NAVAL MEDICAL RESEARCH INST BETHESDA MD
A PRELIMINARY HUMAN ENGINEERING EVALUATION OF HYPERBARIC CONTRO--ETC(U)
MAR 77 W W BANKS, D M HEANEY, A J BACHRACH

A PRELIMINARY HUMAN ENGINEERING EVALUATION
OF HYPERBARIC CONTROL SYSTEMS

Research Subtask M0099-PN.03-3022

March 1977

Fig. 3. Panel #3007872 was rated unsatisfactory in regard to the specification of component accessibility. (The human operator is 5 ft 10 inches tall.)

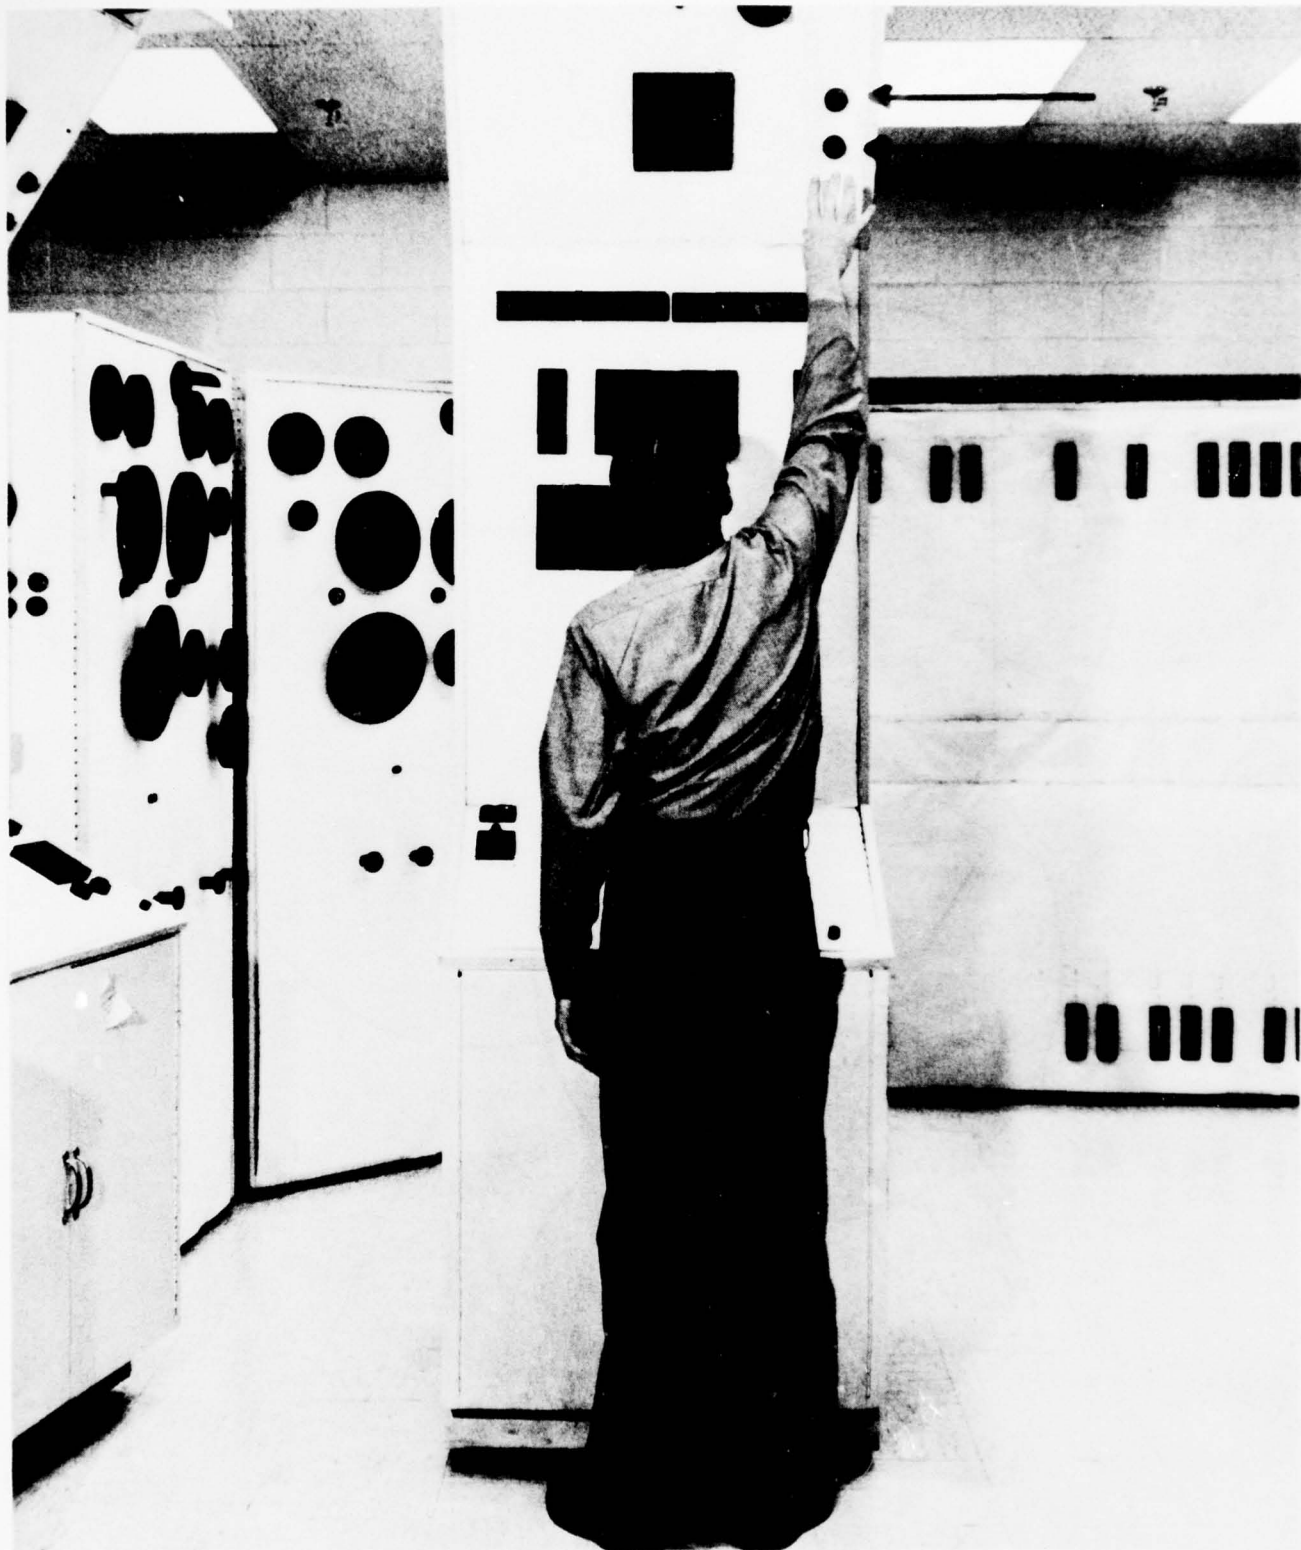
Based on known diver anthropometrics (Beatty and Berghage, 1972), we determined that only Navy divers from the 85th through 99th percentile-height could reach these components without leaning against the console, standing on their toes, or making gross, uncoordinated movements from the standing position. A sample of divers³ representing the 5th through 35% percentile-heights of U.S. Navy divers³ could reach these components only if they were able to stand on an object 3 to 5 inches above the deck. It is recommended that these components be moved at least 6 inches downward toward the lower console.

Figures 3 and 4 present an illustrative representation of the problem. The arrows are pointing to the five components listed above.

Fig. 5. Local panel #3007874 shows the relative position of the sanitary drain controls. This side panel should be swung toward the front so that all controls and indicators are in the monitor's line of sight.

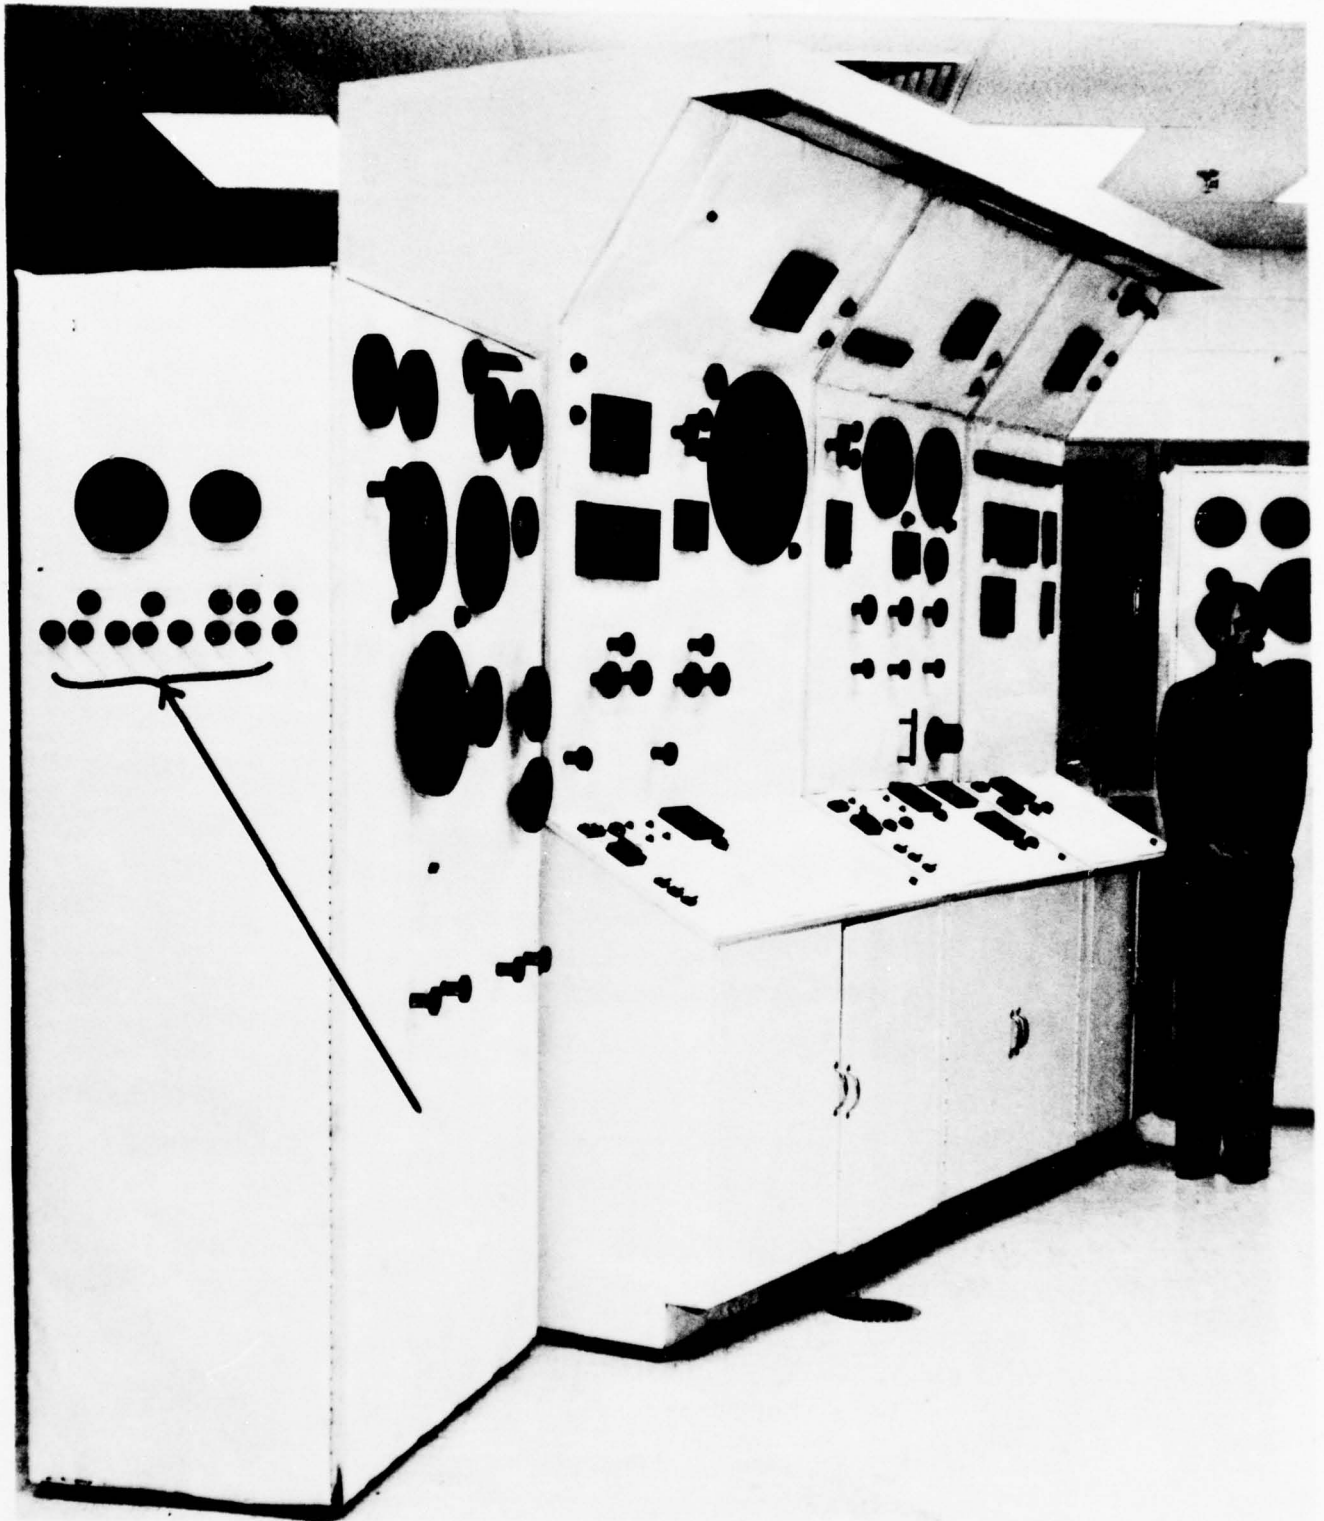
Direct observation revealed that components located on the left side of the local panel in Fig. 5 were accessible only if an operator/monitor walked from the front of the console to the left side of the panel. These components, all relating to sanitary-tank control, are listed: pressure indicator, differential pressure, isolation valve, pressure button, vent, flush, and drain.

When viewing the front of the same local panel (Fig. 5), these components cannot be seen. To manipulate the components, the operator must physically move around to the side, leaving the front of the local panel unmonitored.

It is recommended that the components listed above be displayed on the front of the panel. This could be accomplished by swinging the side panel out and around so that it faces the operator.

Fig. 6. Control panel #3007874 (left) has its control meter shut-off valves inconsistently placed in relation to control panel #3007871 (right). Note arrows.

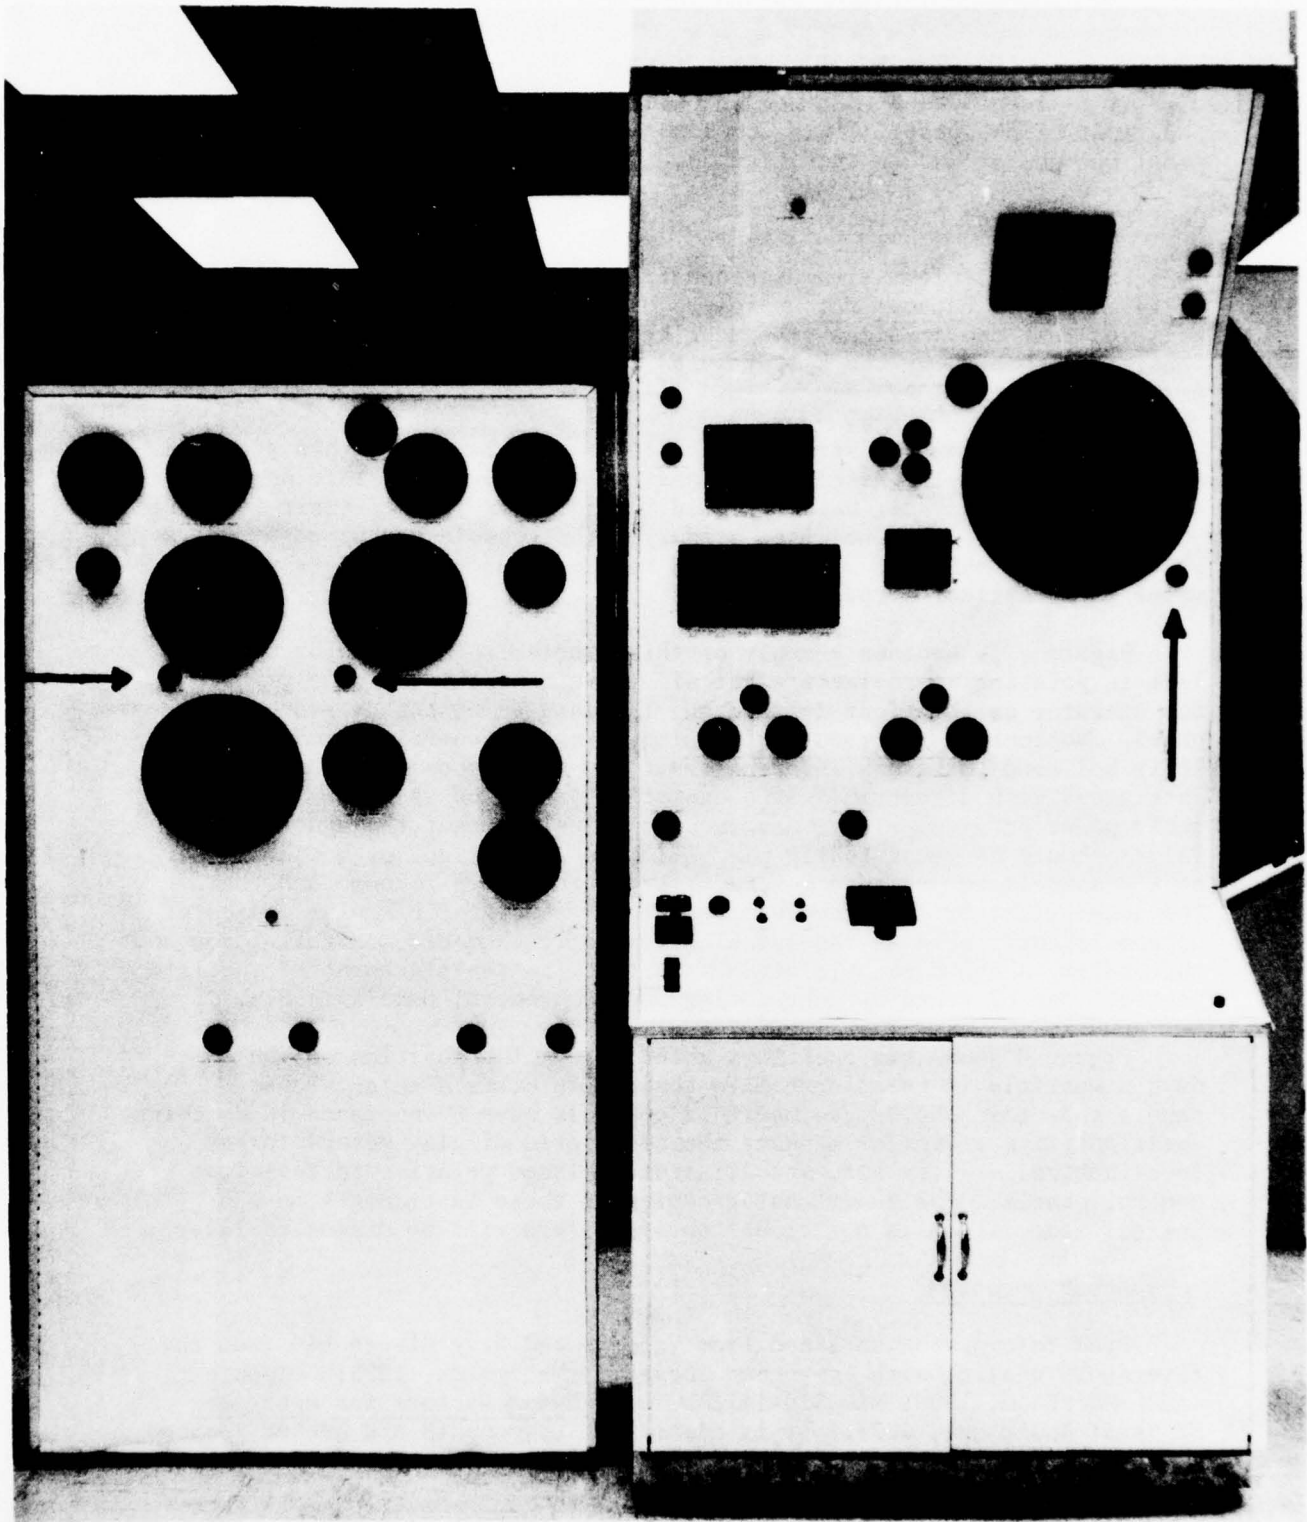
Figure 6 is an illustrative example of a violation of this standard. Note that the display panel of the control console on the left has two pressure meter shut-off valves placed to the lower left of their respective meters on this local panel (see arrows). The console on the right has a pressure meter shut-off valve located to the lower right of its respective meter (see vertical arrow).

Fig. 7. Control panel #3007874 (right) has its control meter shut-off valves inconsistently placed in relation to control panel #3007872 (left). The men in the picture are pointing to these controls.

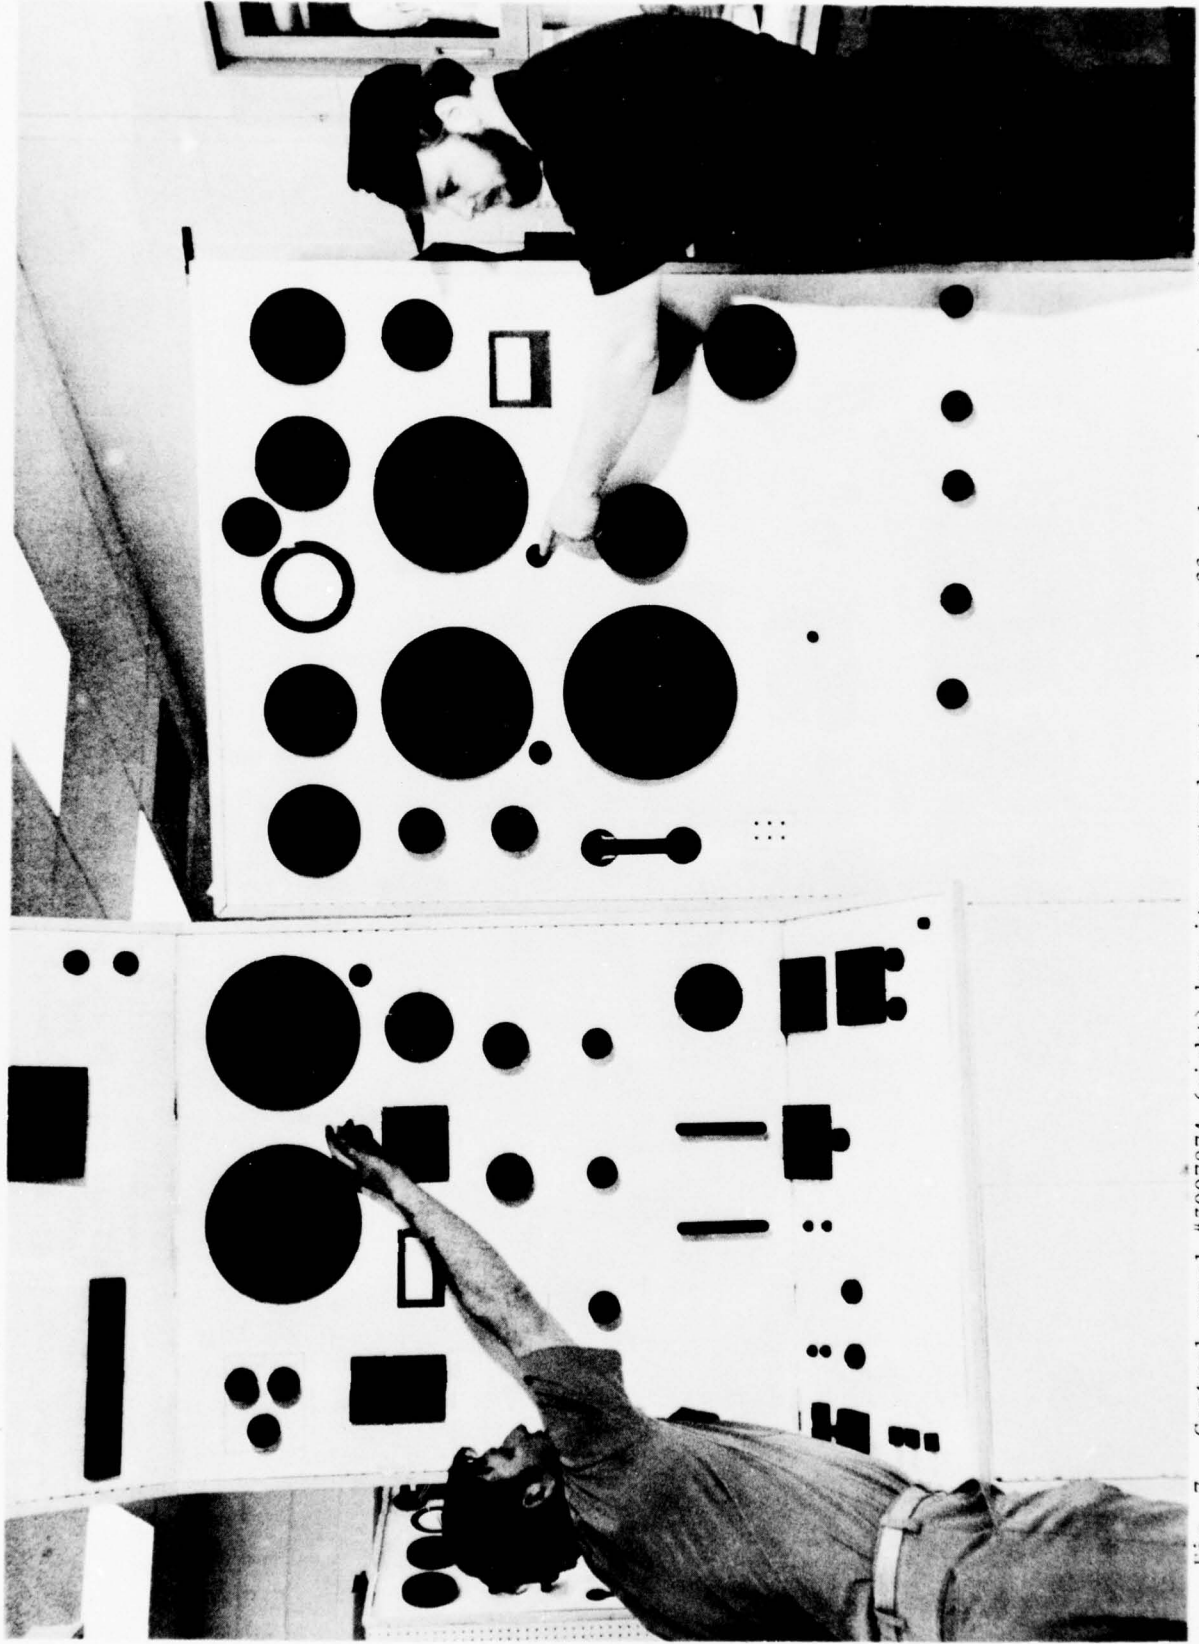
Figure 7 is another example of this problem. The operator on the left is pointing to the meter-shut off valve on one local panel, while the operator on the right is touching the same component on another panel. Notice the reversed positioning of these controls (inconsistency). It is believed that such an arrangement may lead to operator confusion. Interviews with divers indicated that this situation is undesirable from their point of view. Their unanimous opinion was that the shut-off valves should be consistently placed to the lower right or bottom center of the associated pressure meters. It is therefore recommended that the lower-right or lower-center area of an associated circular indicator be consistently used as the location for meter shut-off controls throughout the system. Another example of inconsistency in the placement of specific controls can be found by contrasting the two control panels in Fig. 7.

Fig. 8. The oxygen manifold controls are inconsistently placed with respect to control panels #3007872 (left) and #3007870 (right). The men are pointing to these controls (upper arms). Their lower arms are pointing to the display meters.

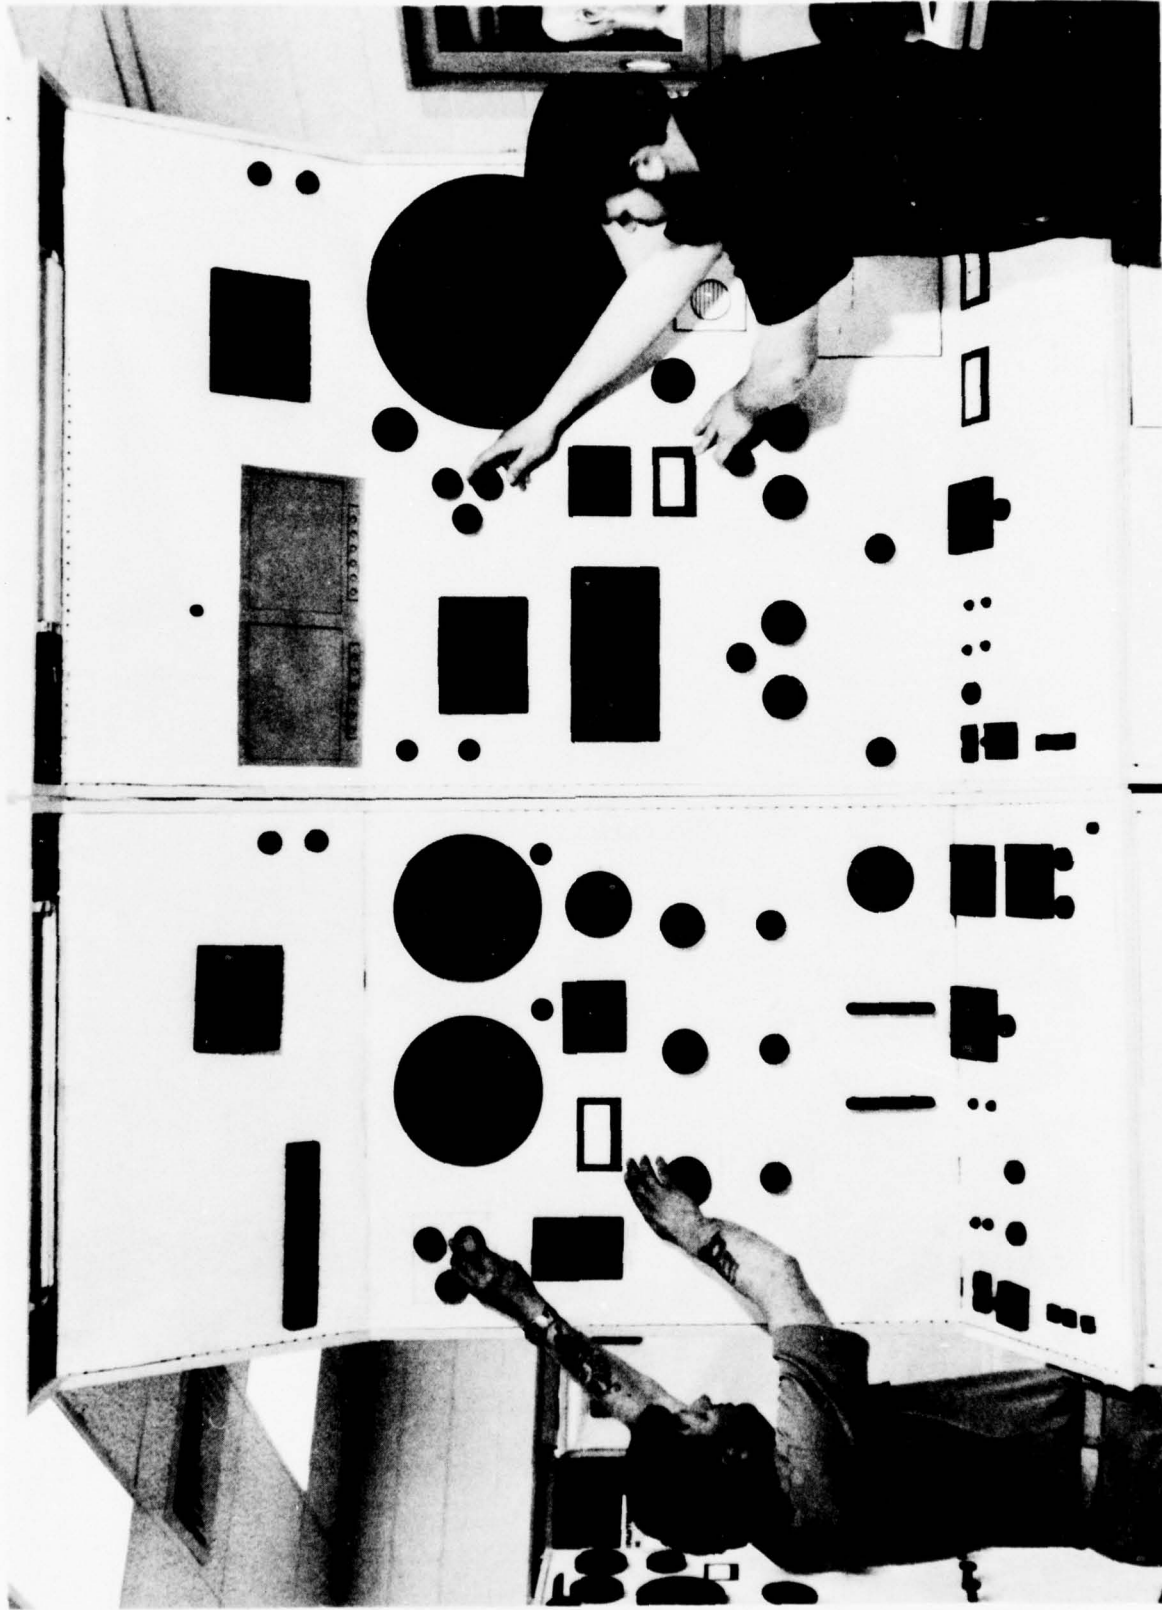
Figure 8 shows two operators pointing out the position of the oxygen manifold in relationship to the oxygen meter display. These panels show that the oxygen manifold controls have been placed in different locations. In a similar manner, the associated display meters (oxygen-level controller) are also inconsistently placed relative to these two control panels. The functional grouping of these instruments in a logical association is not at all obvious. This will be discussed later.

Another example of poor control-display relationships is demonstrated in Fig. 8. Without telling divers the names of blocked-in controls on the panel mock-ups, we asked them to point out the display that they felt to be most likely related to the oxygen manifold. In each instance they picked the FES differential pressure indicator, which of course was incorrect. This demonstration led us to conclude that the oxygen control indicator was not placed properly in relationship to the oxygen manifold controls. We recommend that this situation be changed. To increase the perceived relationship between these instruments, we suggest that they be moved physically closer together in a tight group bounded by strip-lines.
